Project Address: 2445 Fontaine Dr.  
Project Name: Chuck E. Cheese  
Plan Review By: Gil Resendiz  
Plan Check #: 00-02734 1<sup>st</sup> Comments

Re: Plan Check #00-02734  
Chuck E Cheese's #3001  
2445 Fontaine Road  
San Jose, Ca 95121  
Project #98-200

**RE: Plan Check #00-02734  
Chuck E. Cheese's #3001  
2445 Fontaine Road  
San José, CA  
Project #98-200**

Plan Check No. 00-02734

# ERT Series

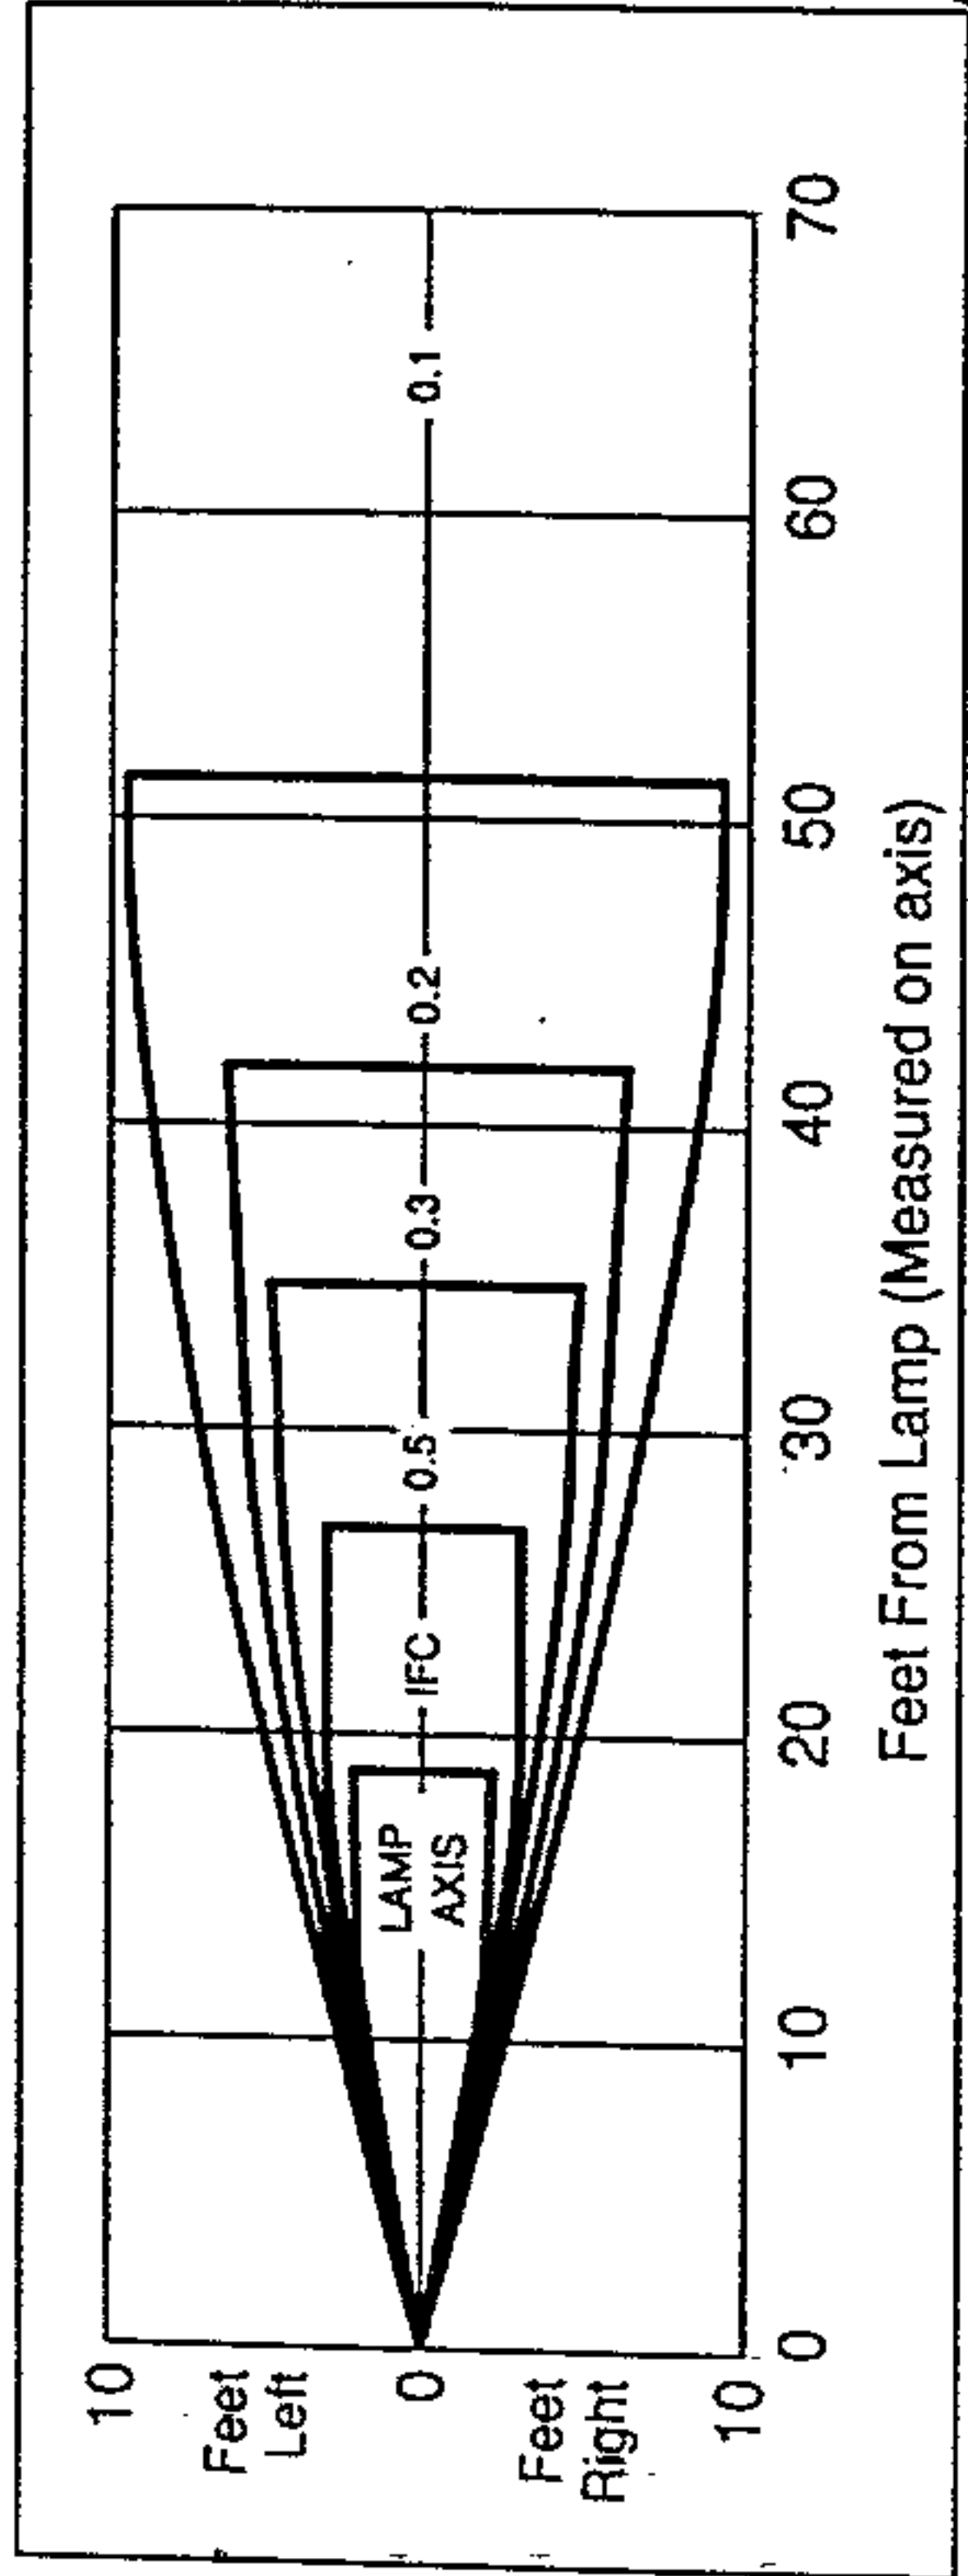
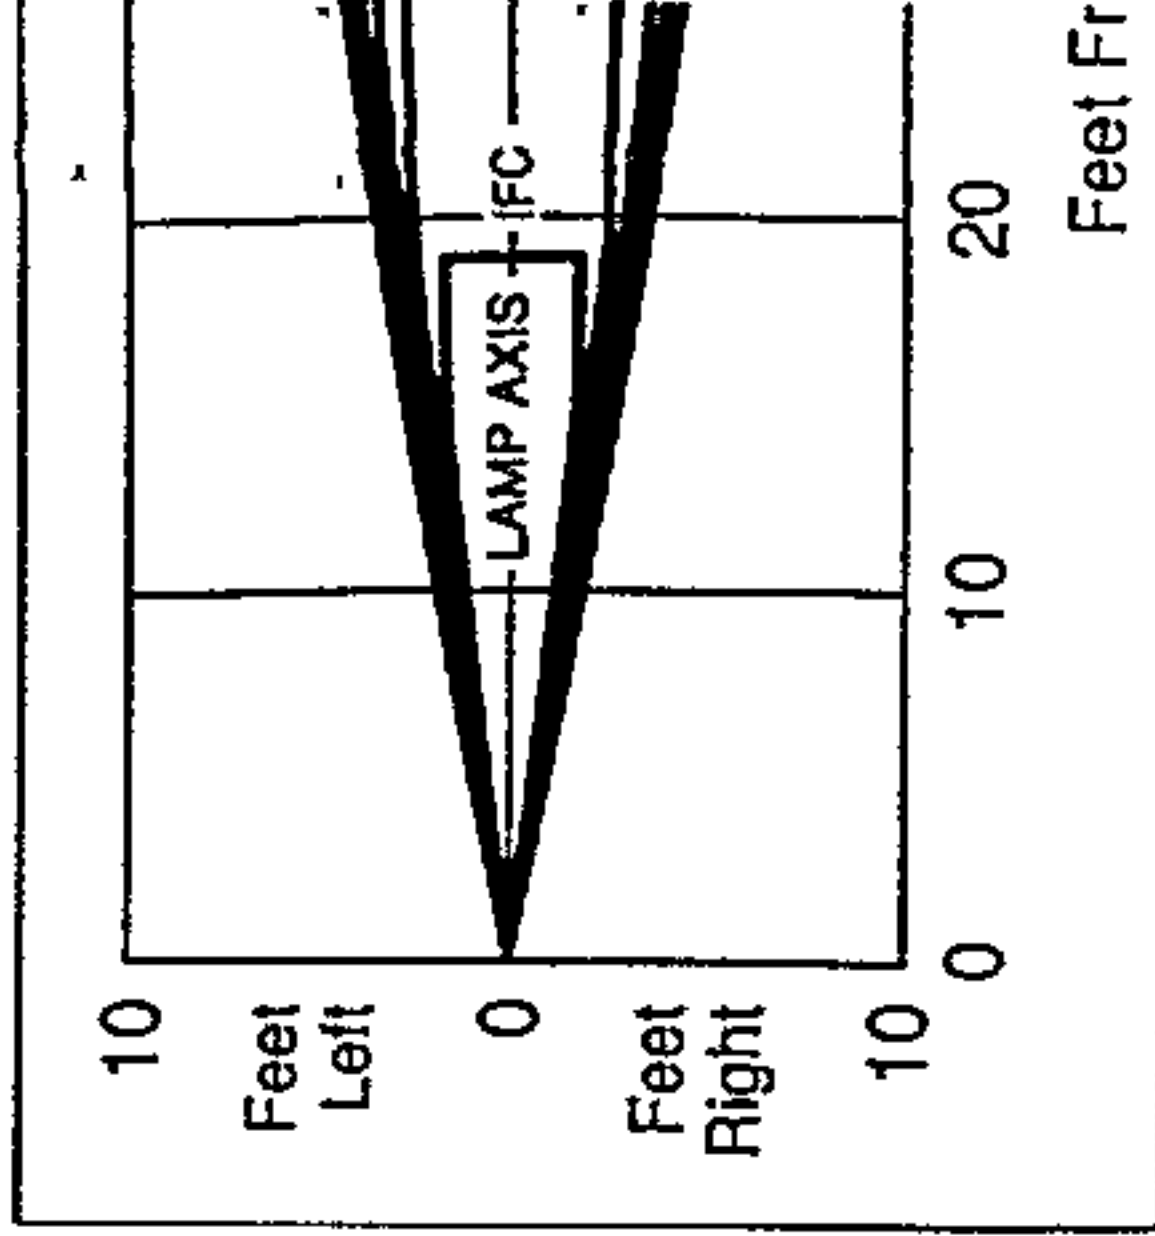
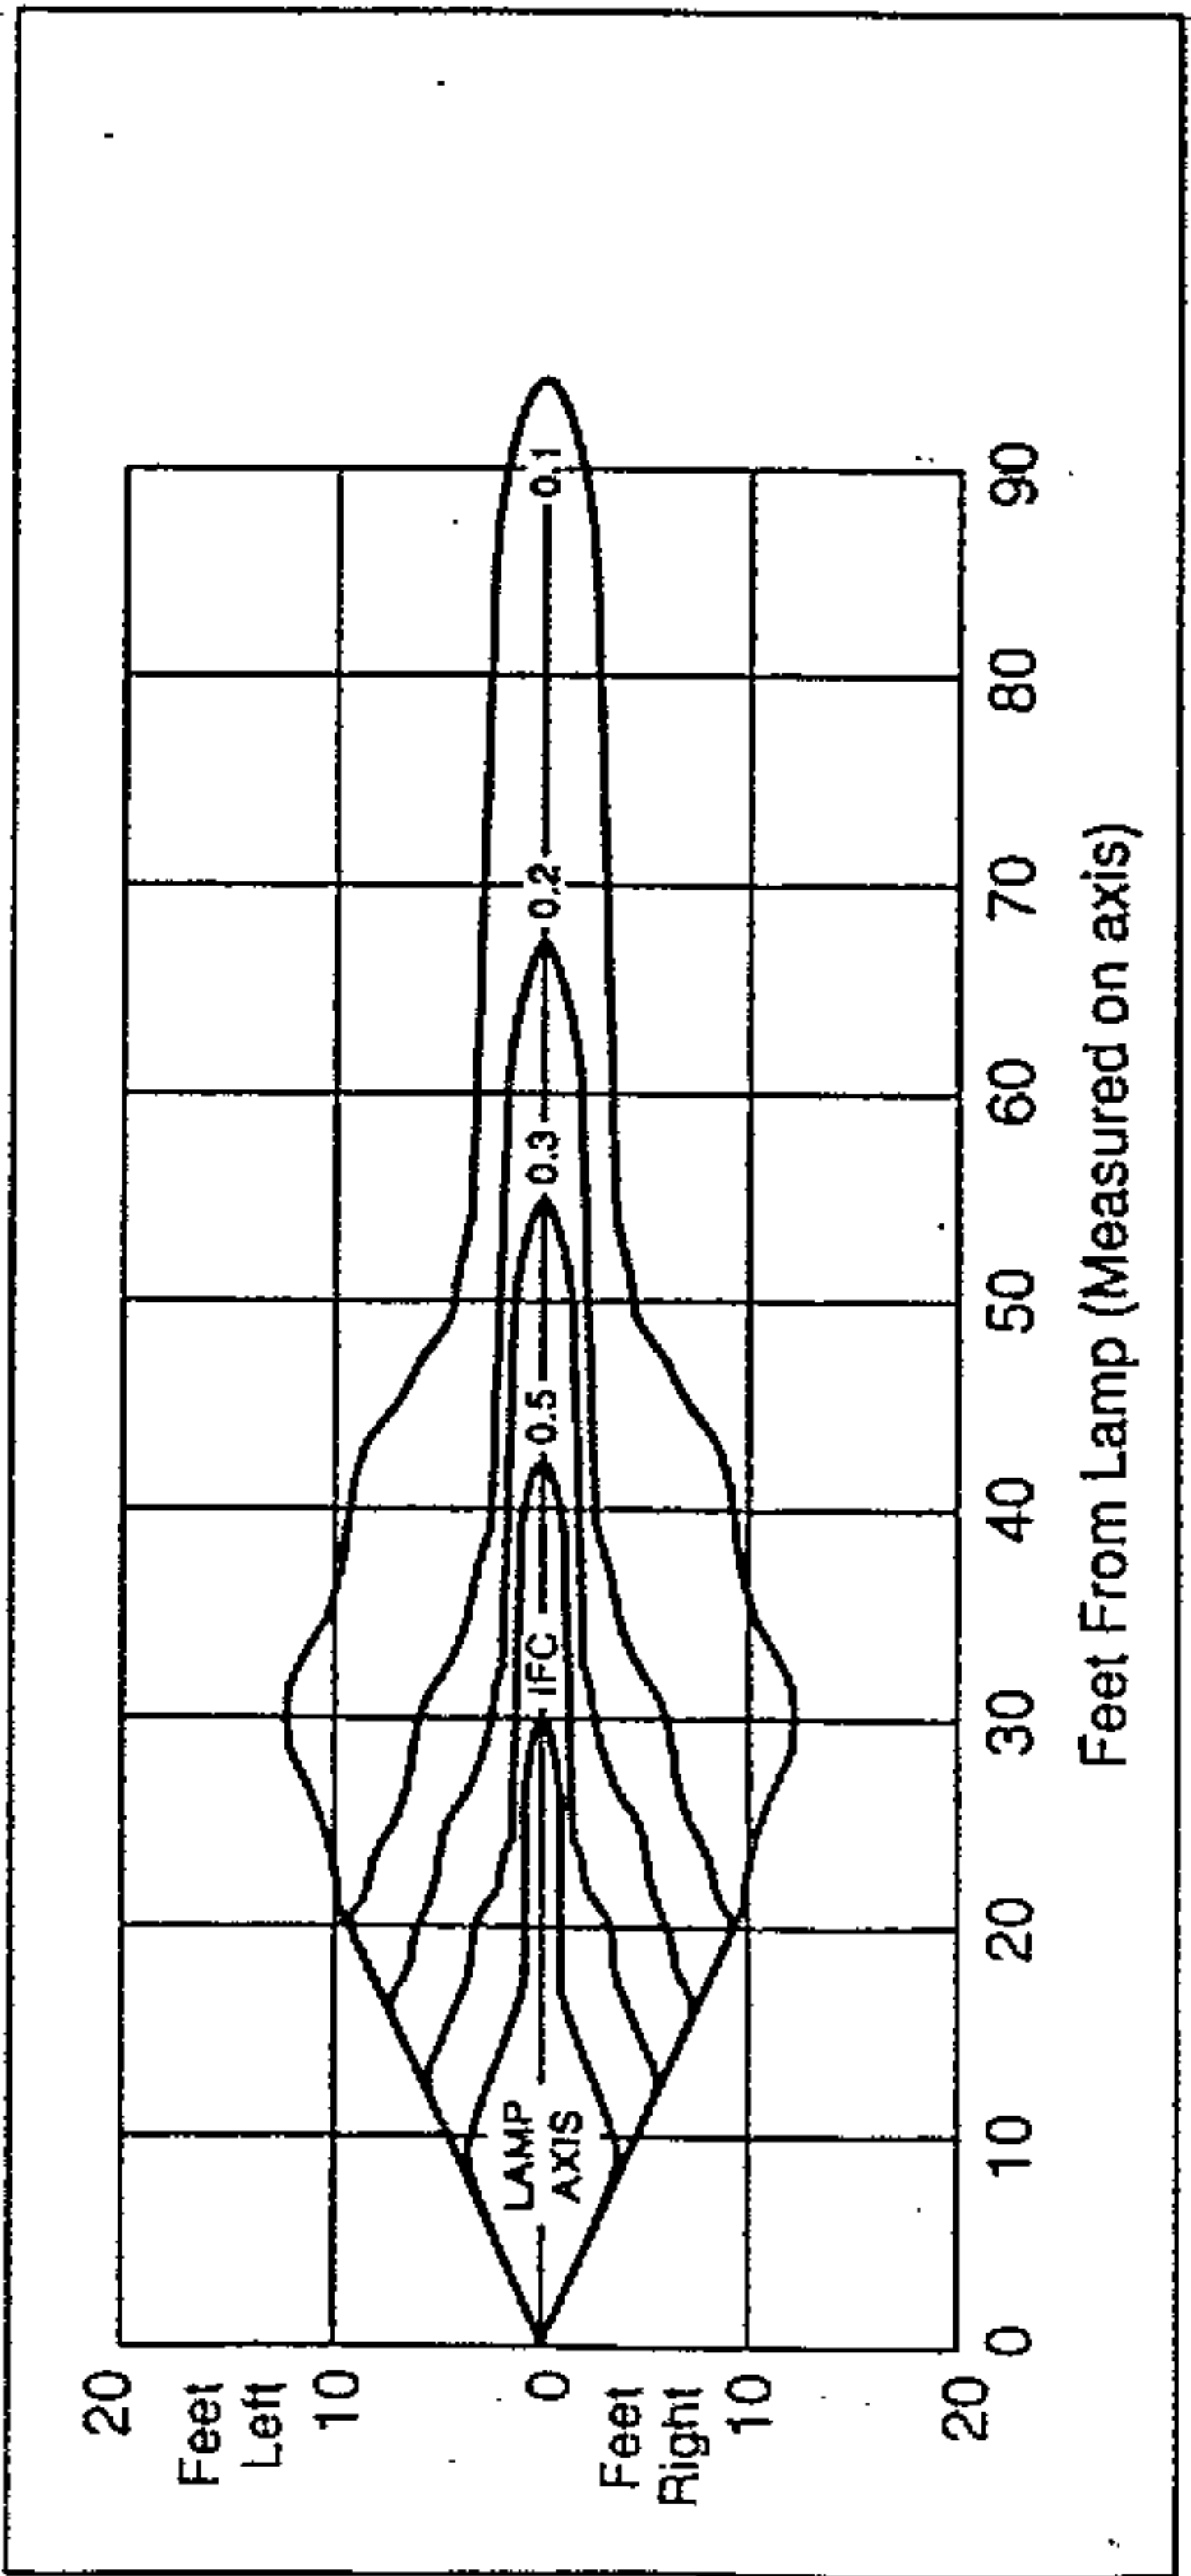
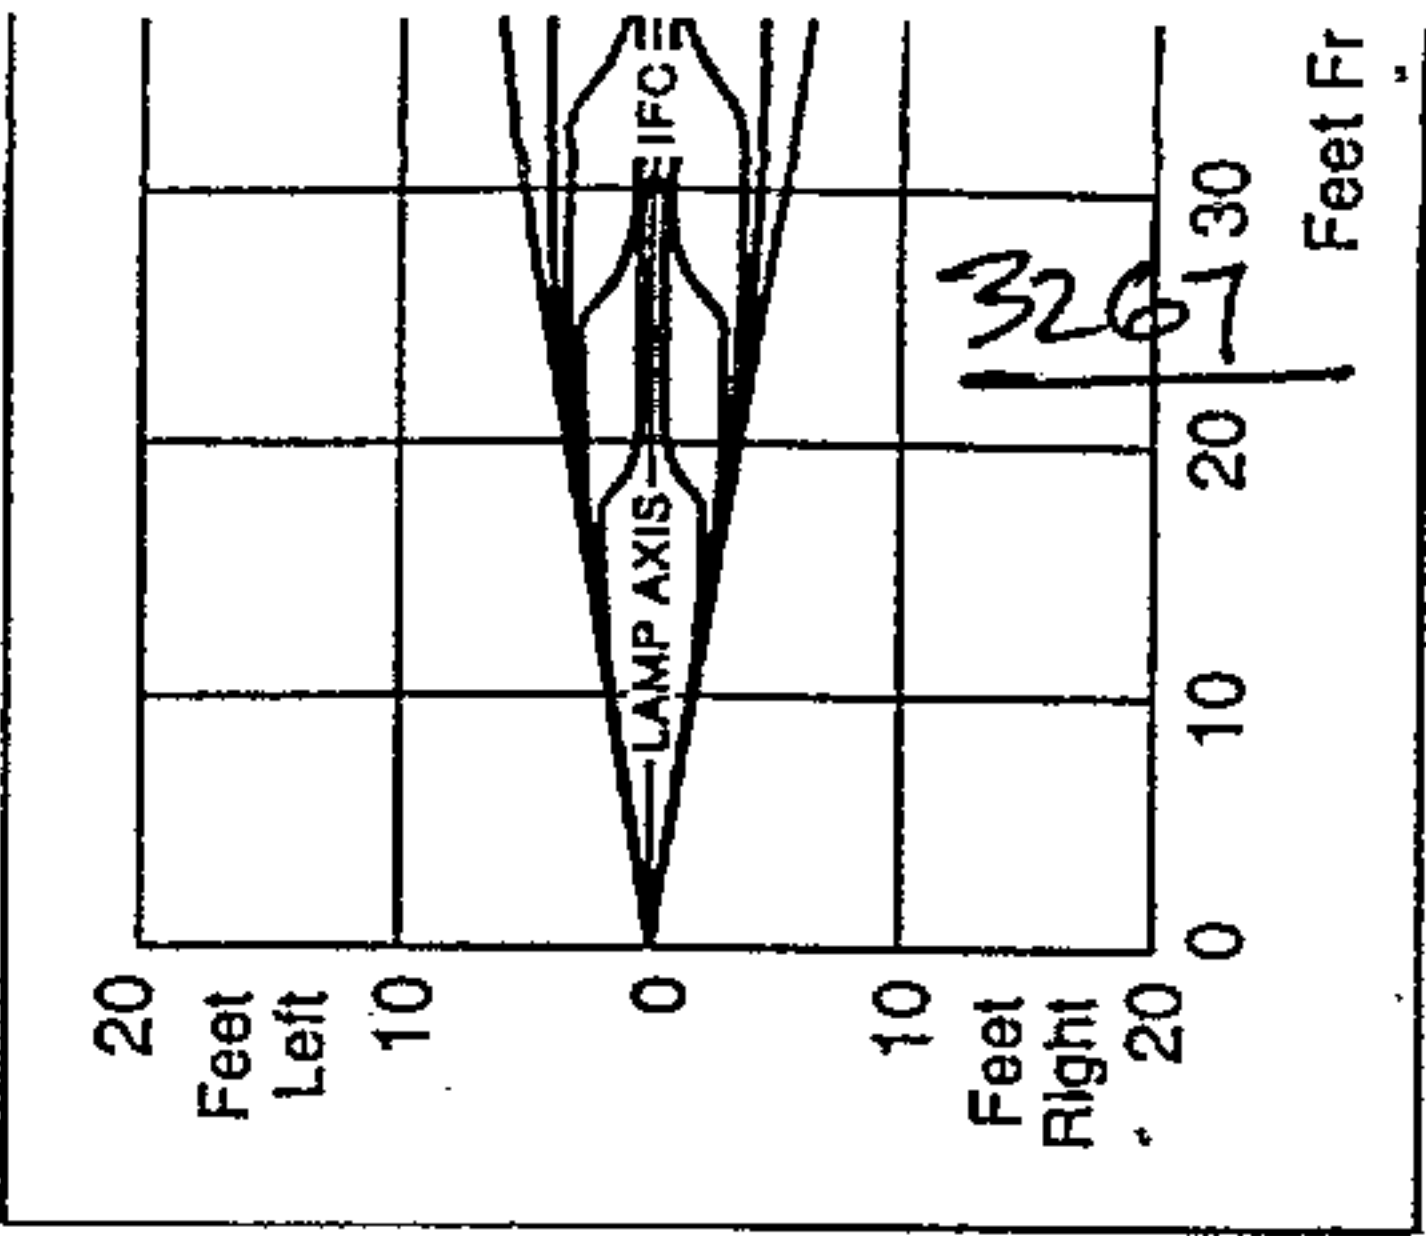
- 1. Refer to sheet T24 (Title 24) and attached Energy Calculations prepared by Title 24-Data, LP.
- 2. Refer to revisions on sheet E1 (including existing load note), attached letter from PG&E of maximum kW, revisions on sheet E2 and attached study set of one (1) foot-candle curves on emergency lights.
